GOVERNMENT OF THE DISTRICT OF COLUMBIA
DEPARTMENT OF TRANSPORTATION

MEMORANDUM

SUBJECT: BZA Case No. 19816 – 2461 Wisconsin Avenue NW

Figure 1 – Site Plan (Source: Wells + Associates, July 2018, Comprehensive Transportation Review, Figure 2)

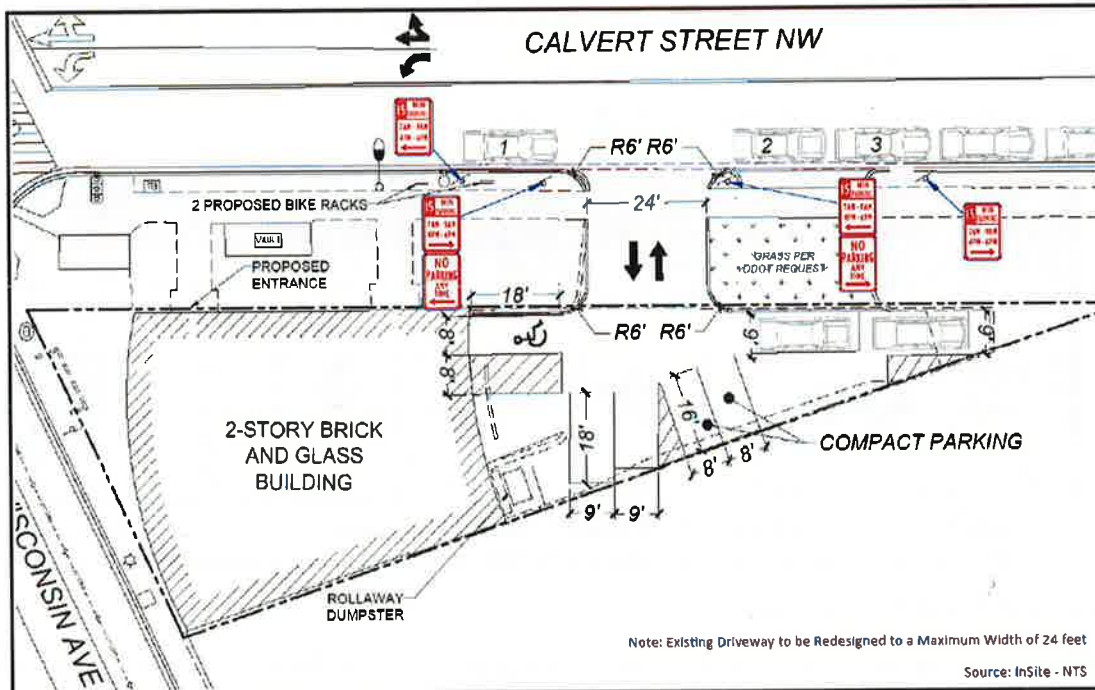
During the design review process, the Applicant worked with DDOT to design the lot striping in a manner that will allow cars to enter head-in and exit-head out, however, these maneuvers will in some cases require multiple point turning movements. Figure 1 shows the Applicant’s parking lot.

Per Subtitle C § 714.2, the Applicant's surface parking will need to be screened with a wall, solid fence, or evergreen hedges of at least 42 inches. To maintain the number of parking spaces provided in the parking lot, the Applicant will not be able to provide screening on private property. The Applicant has the option of either requesting relief from the BZA or providing the required screening within public space. DDOT notes that fencing within public space may not be above 42 inches high and cannot be opaque. Therefore, if the Applicant chooses not to request relief from the screening requirements, its public space package should include 42-inch hedges around the perimeter of the lot.

- Per Subtitle C § 714.2, the Applicant is required to screen its surface parking lot and should request 42" hedges within public space around the lot's perimeter; and
